Document type
Independent Environmental Audit

Date
January, 2025

Newcastle Grammar School Park Campus

Independent Environmental Audit #3

Figure 3-1: Arborist Recommendation for TPZ fencing

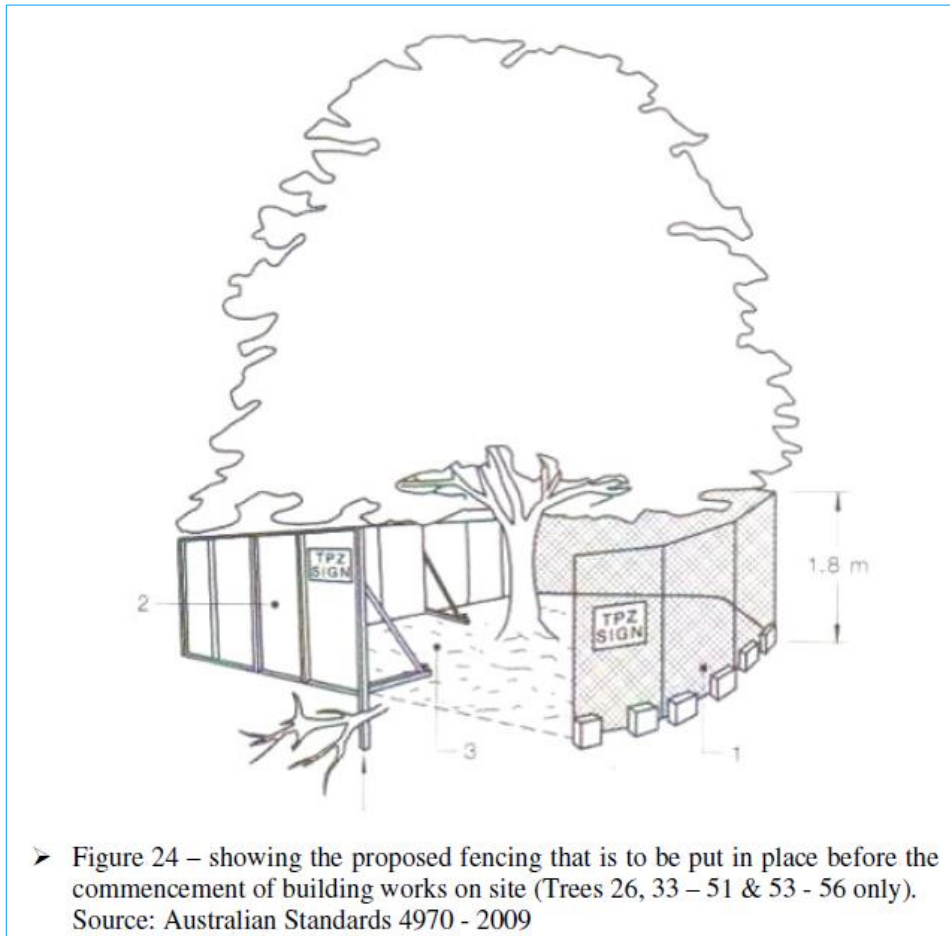
At the time of site inspection, the TPZ was observed to be in place for trees identified as '34' and '35'. The remainder of the trees were located on the other side of the construction fencing and away from construction works. The trees also were observed to have tree hoarding in place round the trunk which was not a recommendation of the Arborist report but implemented as additional protection (refer to photos 9 and 10 of **Appendix 3**). The Auditors did not inspect other trees identified for retention as they were located on the other side of the construction fencing within the school grounds and therefore, suitably protected from construction works.

The Auditors consider that the recommendations in the Arborist Report were adhered to by CPG during the Audit Period. Further, the trees have been confirmed to be in a healthy condition following inspection by a qualified arborist as per the *Construction Stage Inspection Report (Arborist)* by Abacus Tree Services dated 23 August 2024. However, the requirements of the Arborist Report are not clearly documented within the EMP. It is recommended that the EMP be revised to incorporate the management measures from the Arborist Report for clarity in documentation (refer to **Section 4.1**).

Figure 3-2: Landscape Plan (Drawing No. 2020_08 NG_DA_05) by SHAC Architects

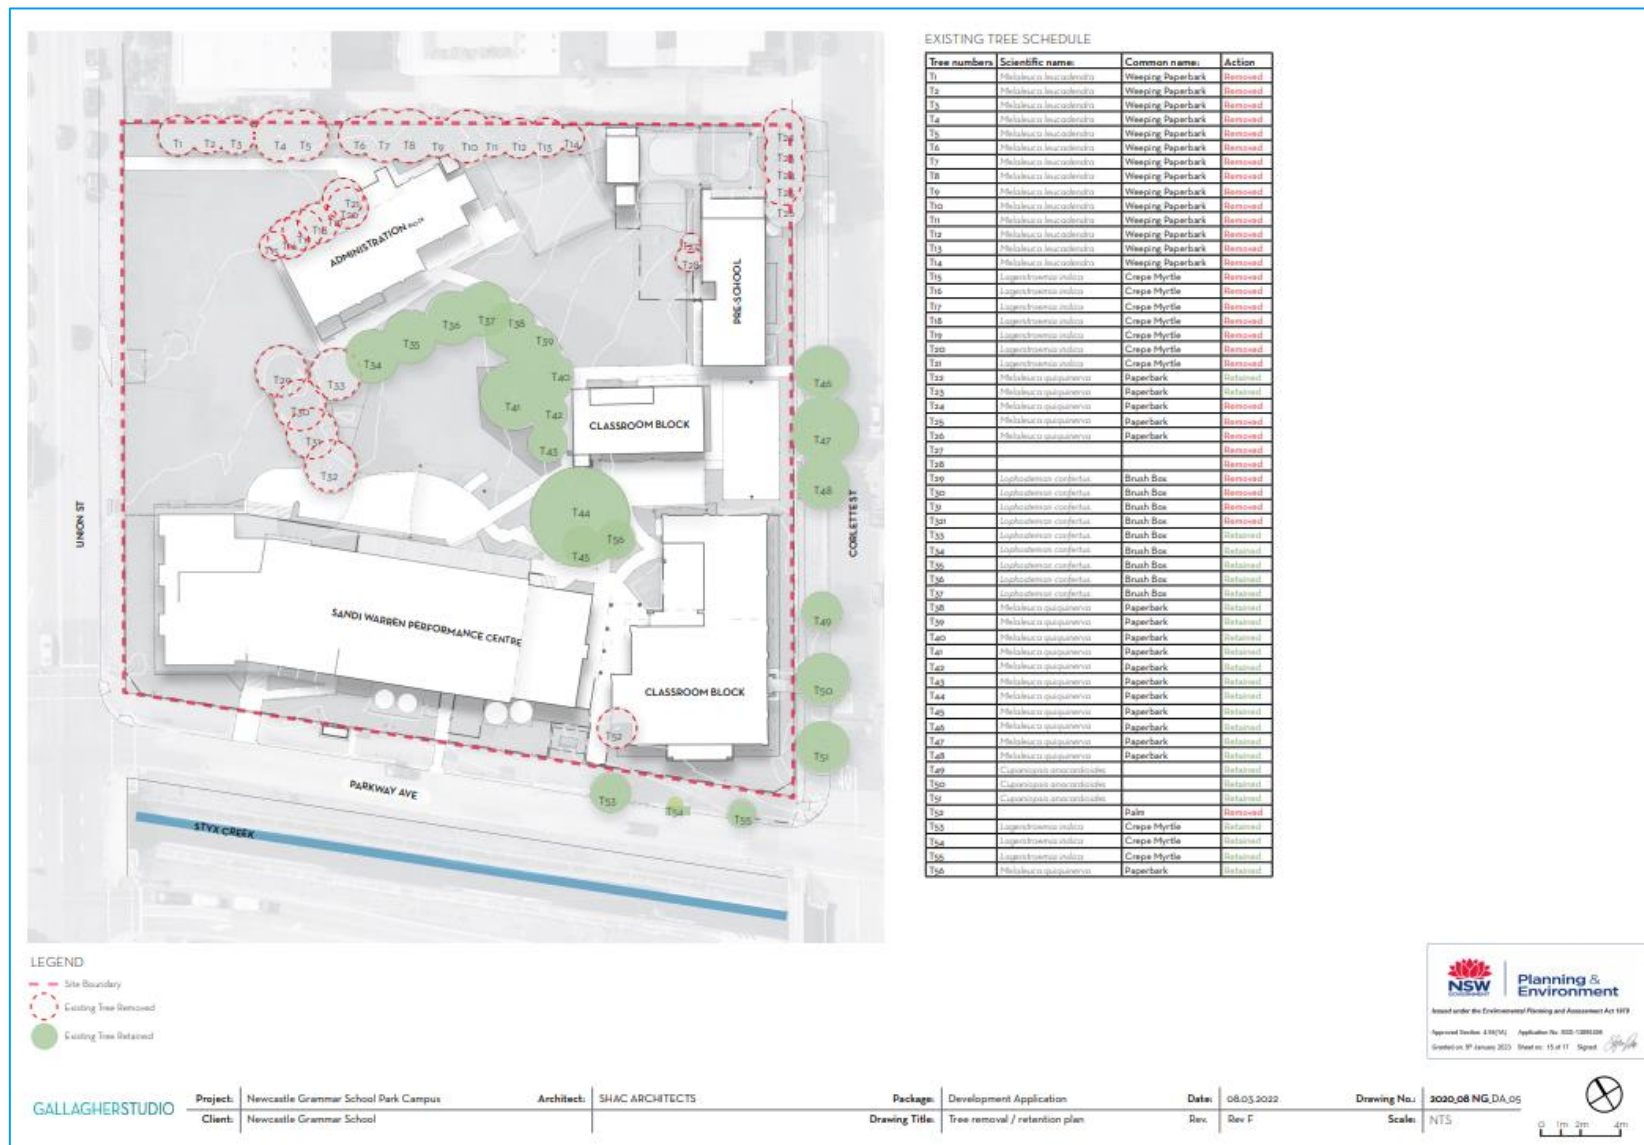
The Auditors also note there are errors in the approved Landscape Plans and contradictory findings in the Arborist Report with regards to the management of Tree '33' as follows:

The Landscape Plan (Drawing No. 2020_08 NG_DA_05) (reproduced as **Figure 3-2** below) shows the same contradiction around Tree 33. In the plan Tree 33 is identified as an 'existing tree to be removed' whilst in the adjacent table titled 'Existing Tree Schedule' Tree 33 is identified to be 'retained' in the 'action' column.

At the time of site inspection, the Auditors confirmed that Tree 33 was in fact removed but the Auditors reiterate that the requirements concerning tree protection in the pre-approval documents including the Arborist Report and the post-approval documents including the EMP are not clear. This lack of clarity may have contributed to the previous implementation and management issues with of this aspect as evidenced in the warning letters (refer to **Table 3-1**) received by the Applicant from the DPHI for matters that occurred outside of this Audit Period.
